PROJECT: Pump Station 19 Decommission Project
City Project Number SS2018-01

ADDENDUM NO. 1
To the Contract Provisions for
CITY OF FERNDAL, WASHINGTON

Pump Station 19 Decommission Project
City Project Number SS2018-01

ADDENDUM 1

THORNTON STREET
PS19 DECOMMISSIONING
PLAN AND PROFILE - STA 10+50 TO STA 15+00

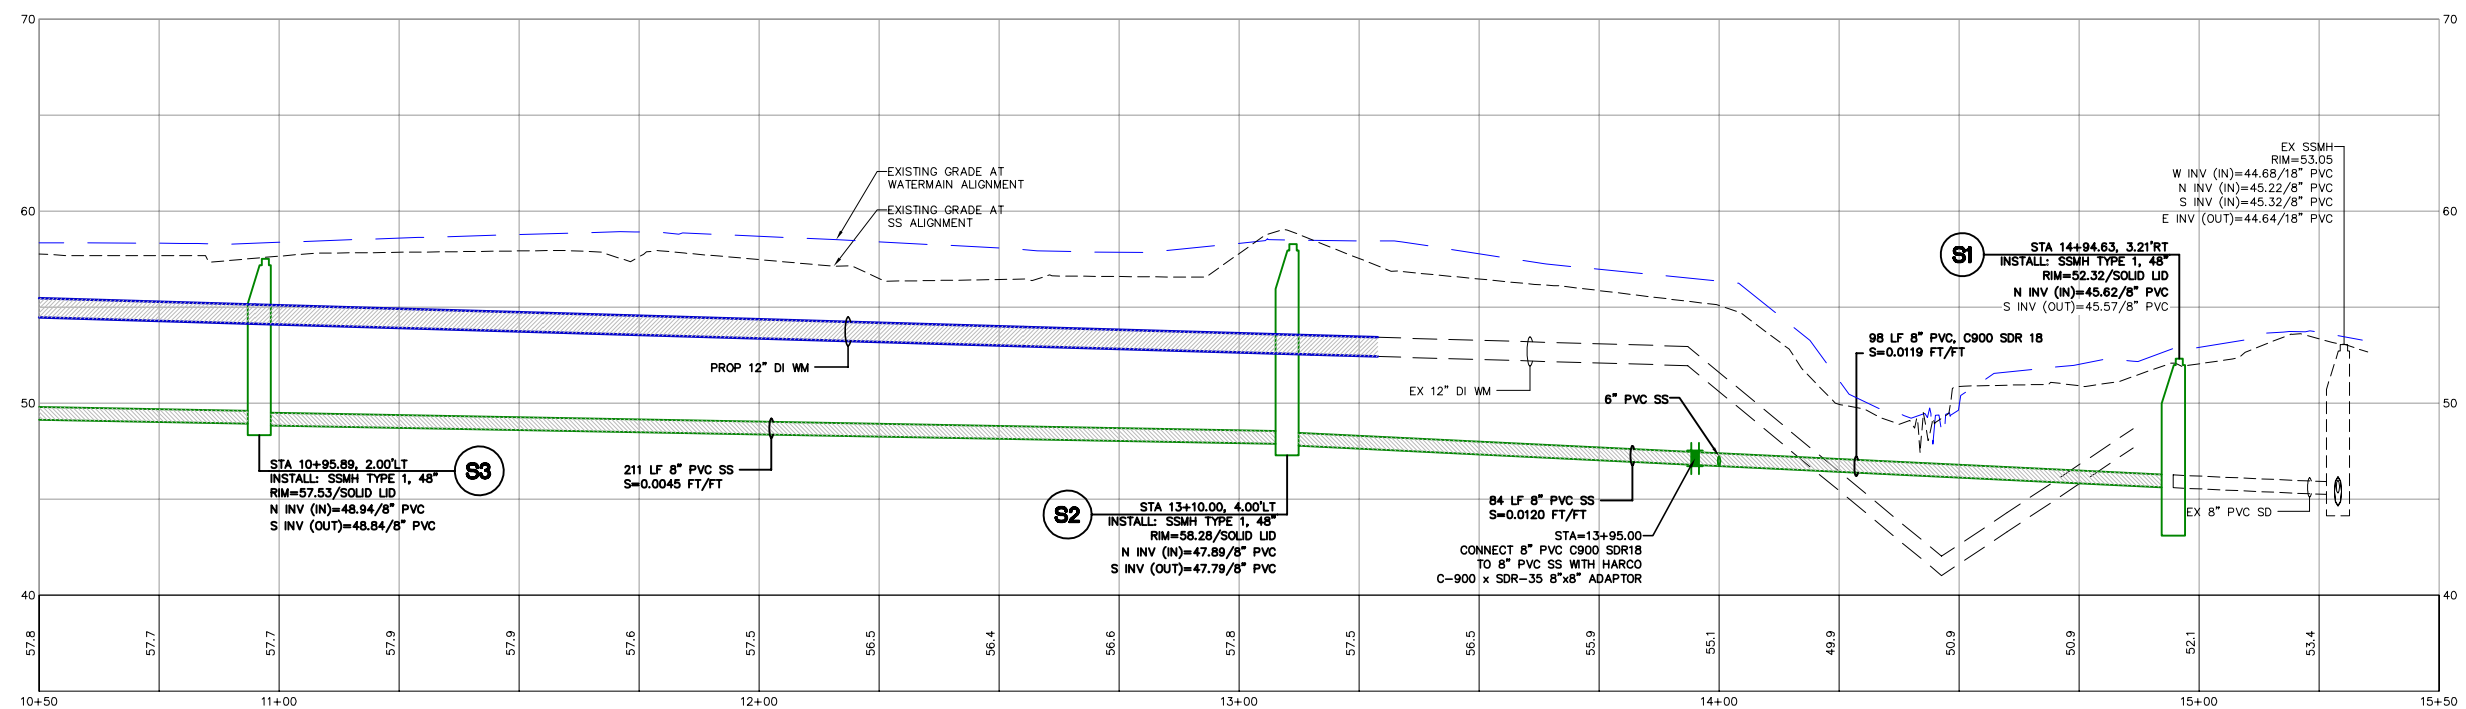
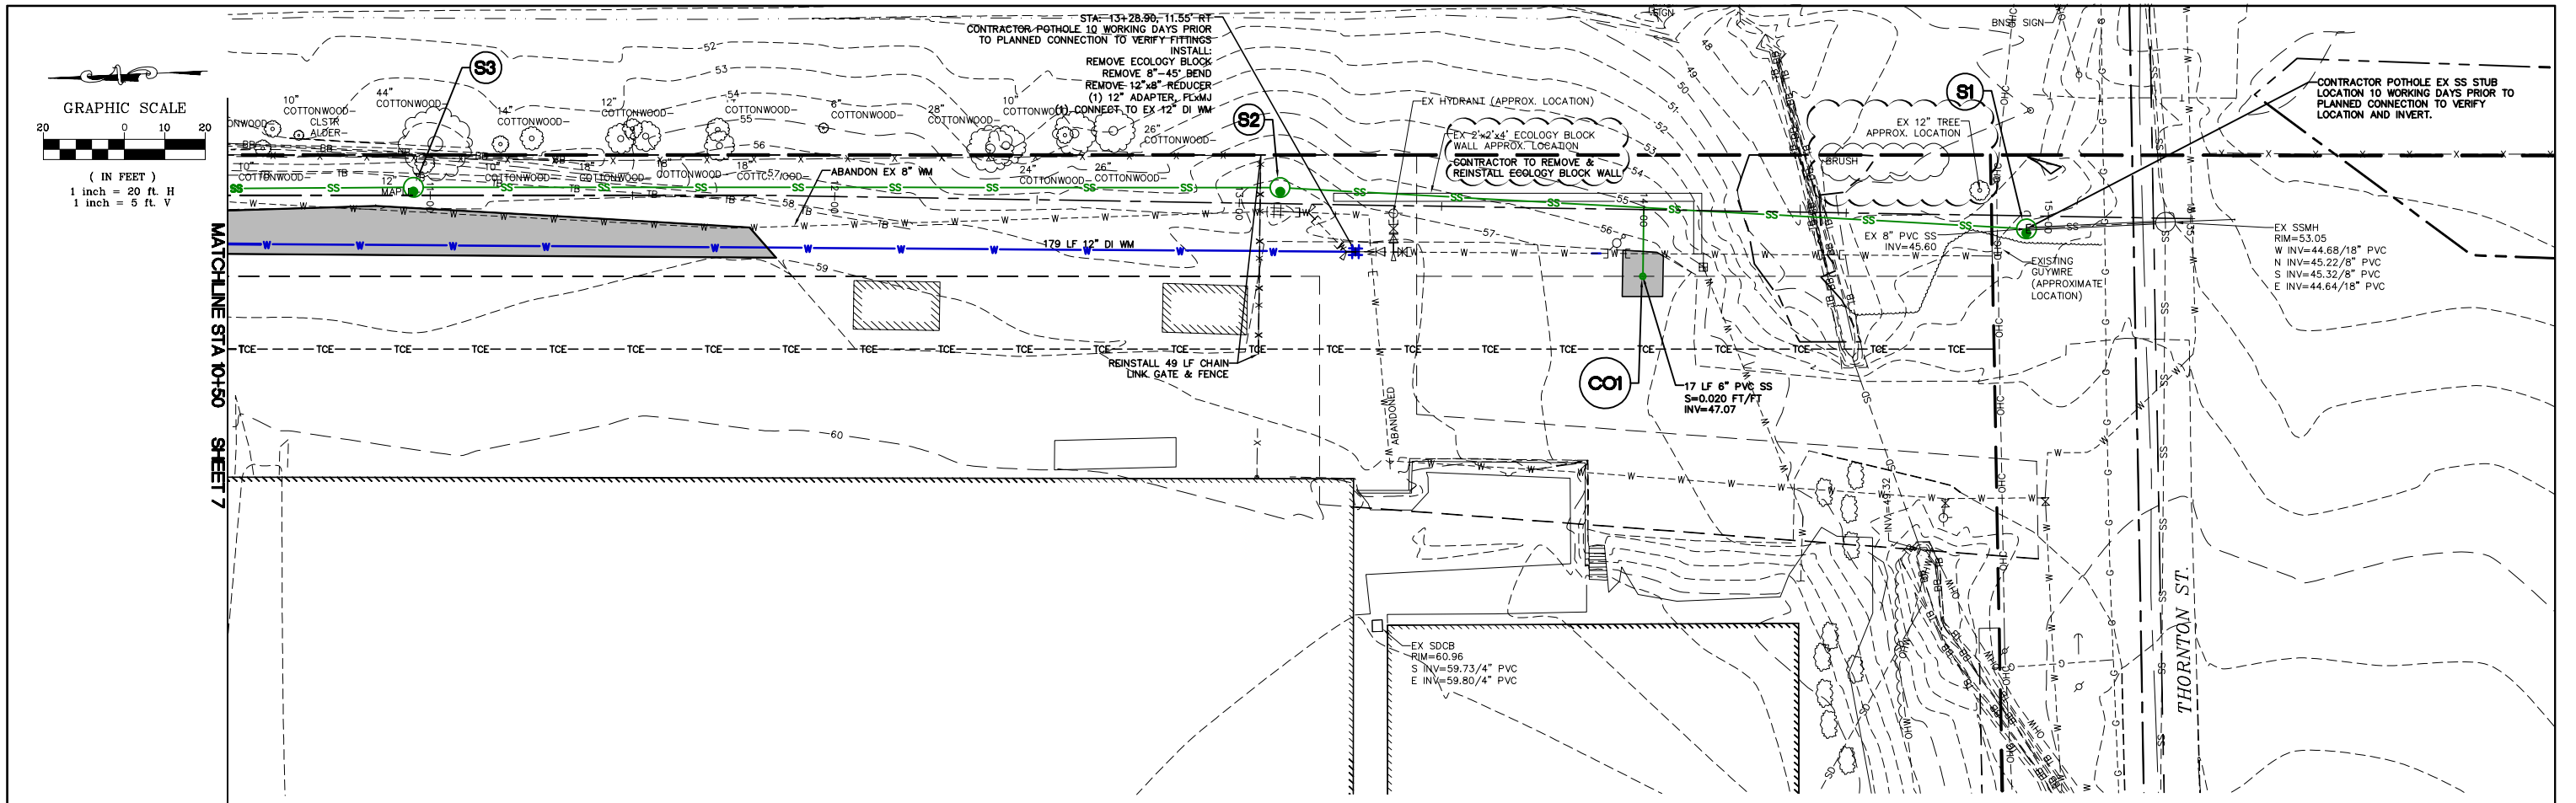
Sheet 8

- Existing trees and brush were added.
- A note regarding that the Contractor is to remove and reinstall the ecology block wall was added.
